PLAN OF PROPOSED STABLES.

ON PLOT № 435 SHEET K-7.

LYAREE QTR.

No. L.S. 1790 of 1920.

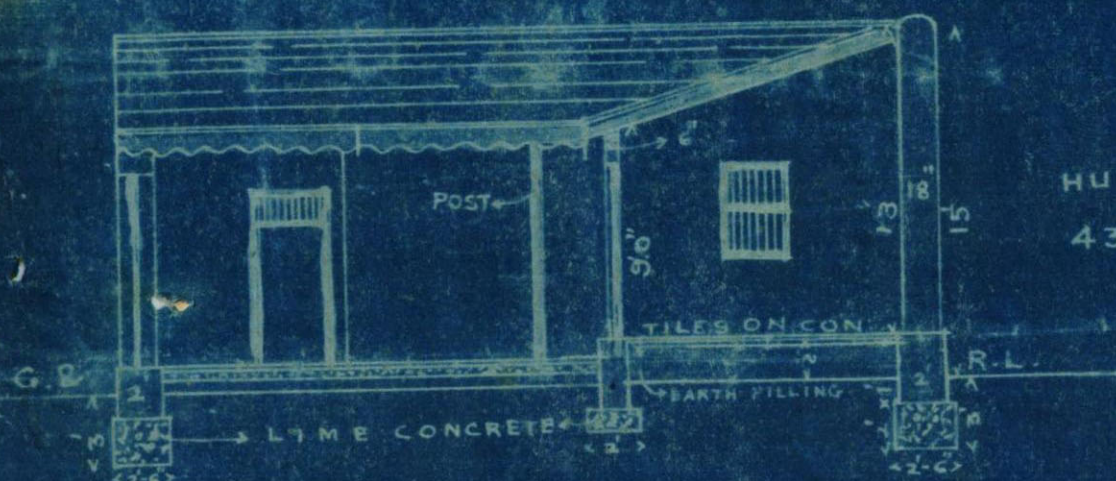
With reference to his letter dated 30th ultimo with a plan for the proposed stables on plot No. 435, K-7 Lyari Quarter Mr. Fatechchand Nebbandas is informed, the plan is badly designed as the stables and syce rooms are badly ventilated.

of 20th March 20, I beg to state that theplan provides for only a single
storeyed building & large open spaces
have been kept. Both the stables &living rooms have less ventilation on
both sides. However to meet yourwishes, I have increased the open
spaces to east & west of living rooms
from 3' to 4'-6" making the openspace about $\frac{1}{3}$ of the whole area.The plinth of the living rooms has
been increased from 1'-0" to 2'-0" above
ground. I trust that now you will
kindly approve of the plan & allow
me to build for which I will be
greatly obliged.Yours faithfully
I beg to remain,
Sir

PLAN OF PROPOSED STABLES.

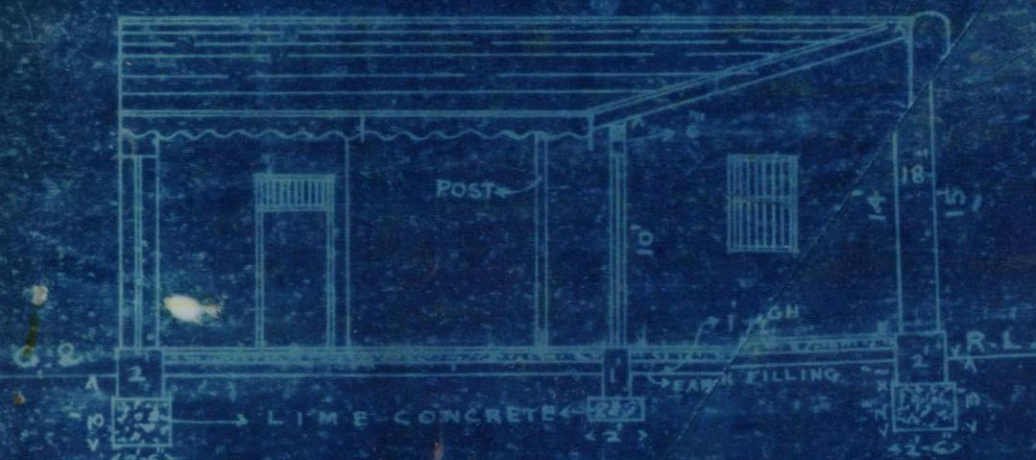
1. The plan is badly designed. The syces rooms must be kept on one side of the plot clear of the stables and have a plinth level 2 feet above the road level. In their present position they are insanitary.

2. The stables must be properly paved and drained.

*Pye's rooms should be
absolutely separate from 1 two
stables*

Building Surveyor's Report In with respect to this I beg to report. the H.O.'s objections are to be considered. The rooms must be accommodated on one side of the plot. The plinth level of the stable rooms must be two feet above G.S. level. There appears no other objection to the plan. R.D.
J. I. Jueas.
 Date 12/3 1920 Building Surveyor.

The plan is badly designed. The stable rooms must be kept on one side of the plot clear of the stable & have a plinth level 2' 6" above the road level. The stable must be properly paved & drained.
